STAFF REPORT  
(Final Plat, Preliminary Plat Approved 8/4/94)

CASE NUMBER: S/D 94-45 LARK ADDITION

STAFF REPORT  
(Preliminary Plat)

CASE NUMBER: S/D 94-45 LARK ADDITION

**EXHIBIT**

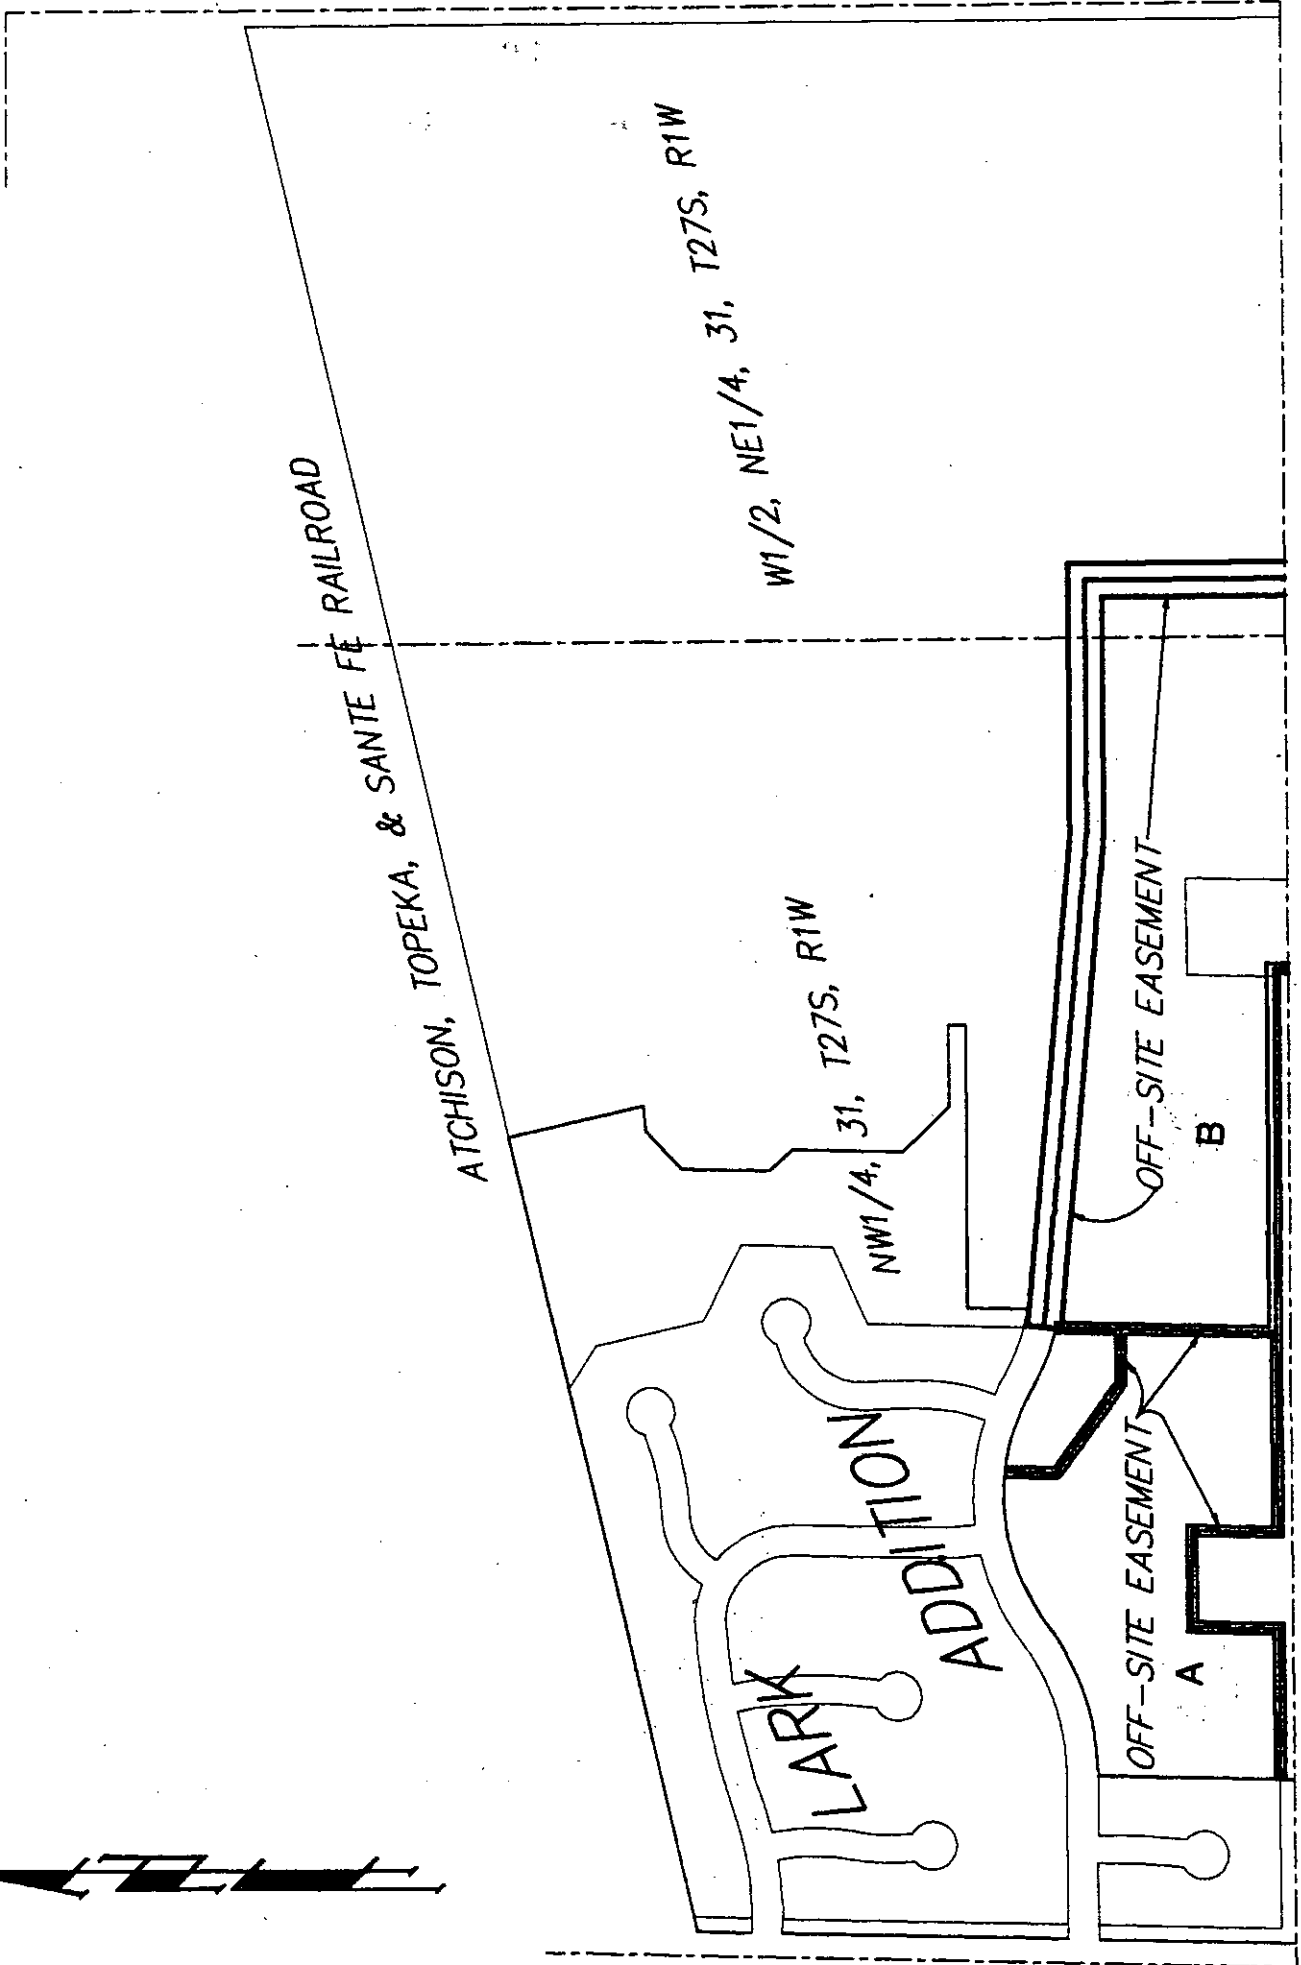
- A. A portion of this site (western two-thirds) is still in the County, under R-1 zoning. However, to plat the lot sizes being shown, all of this area will need to be annexed to Wichita. Before any such portions of this plat can be scheduled for City Council review, these areas will need to be annexed.

- B. The area to the northeast of this site, indicated as an "exception" has been shown on the sketch plat of this addition as being a future church site. Based upon existing residential uses to the east, the residential uses being platted by this plat, the restricted access to this site, and the general character of the area the applicant is advised that a non-residential use for this exception area would not be appropriate and that this exception area should be platted for a church site or residential lots on this plat as well.

- C. The applicant shall guarantee the extension of sanitary sewer to serve the lots being platted.
- D. The applicant shall guarantee the extension of City water to serve the lots being platted. As necessary, this guarantee shall include any needed water line extensions in Lark and 119th Street West.

- E. The applicant shall guarantee the paving of the proposed interior streets. This guarantee shall also provide for the installation of sidewalks. Sidewalk shall be provided along both sides of the collector street alignment involving Dora-Covington-Carr (66-foot right-of-way street) and along one (1) side of each non-cul-de-saced street, i.e., Carr/Milstead, May/Cardington Dora/Prescott, Dora, Mars, Esthner.

- F. City Engineering needs to also indicate any paving requirements for Lark or 119th Street West.
- G. Traffic Engineering also needs to indicate if any traffic improvements need to be considered for this site, in particular for the two entrances to/from 119th Street West.

Also, Traffic Engineering needs to comment upon the alignment of Carr east and west of Lark. That is, is the off-set shown a potential problem for left turning vehicles into this site and the area east of Lark.
- H. The applicant shall guarantee any drainage improvements required by the platting of this property.
- I. The applicant shall guarantee construction of the storm sewers required by this plat.
- J. If improvements are guaranteed by petition, a notarized certificate listing the petitions shall be submitted to the Planning Department for recording.
- K. On the final plat complete access control shall be dedicated and shown for the lots and Reserves adjacent to Lark or 119th Street West.
- L. The final plat shall state in the platlor's text the purposes of the proposed reserves as well as who is to own and maintain the reserves.

- M. Provisions shall be made for ownership and maintenance of the proposed reserves. The applicant shall either form a lot owners' association prior to recording the plat or shall submit a covenant stating when the association will be formed, when the reserves will be deeded to the association and who is to own and maintain the reserves prior to the association taking over those responsibilities. This covenant shall also provide that the homeowners' association will maintain the "parking strip" areas located between this plat's perimeter and the paved or driving surfaces of 119th Street West and Lark.

- N. For those reserves being platted for drainage purposes, the required covenant which provides for ownership and maintenance of the reserves shall grant, to the City, the authority to maintain the drainage reserves in the event the owner(s) fail to do so. The covenant shall provide for the cost of such maintenance to be charged back to the owner(s) by a method similar to special assessments.

- O. The applicant shall submit a covenant which provides for four (4) off-street parking spaces per dwelling unit on each lot which abuts a 58-foot street. The covenant shall inventory the affected lots by lot and block number and shall state that the covenant runs with the land and is binding on future owners and assigns.

- P. The applicant is advised that if any drainage from this site is directed to the adjacent railroad tracks (A. T. & S.F. R.R.) that a letter needs to be submitted to Planning from this railroad indicating their acceptance of such drainage.

- Q. This plat is indicating certain off-site easements. Such easements shall be created by separate instrument and shall be submitted to Planning for recording.

- R. On the final plat, Block Numbers or Letters shall be indicated.
- S. This plat has apparently made good use of existing street names. The representative from the City's Fire Department needs to indicate if any street naming conflicts do exist, however.

- T. Requirements for a final plat (see pages 5-5 through 5-10, Part 4, Article 5 of the MAPC Subdivision Regulations).
- U. Prior to or at the time of submitting the final plat, the applicant shall submit a drainage plan to City Engineering for review and approval.

- Y. The representatives from the utility companies should be prepared to comment on the need for utility easements to be platted on this property.
- Z. The representatives from City Engineering should be prepared to comment on the status of the applicant's drainage concept. Also, Engineering needs to comment on the drainage dedication being shown in the southeast corner of the site. That is, is the dedication acceptable or should the area be platted as a Reserve for drainage purposes.
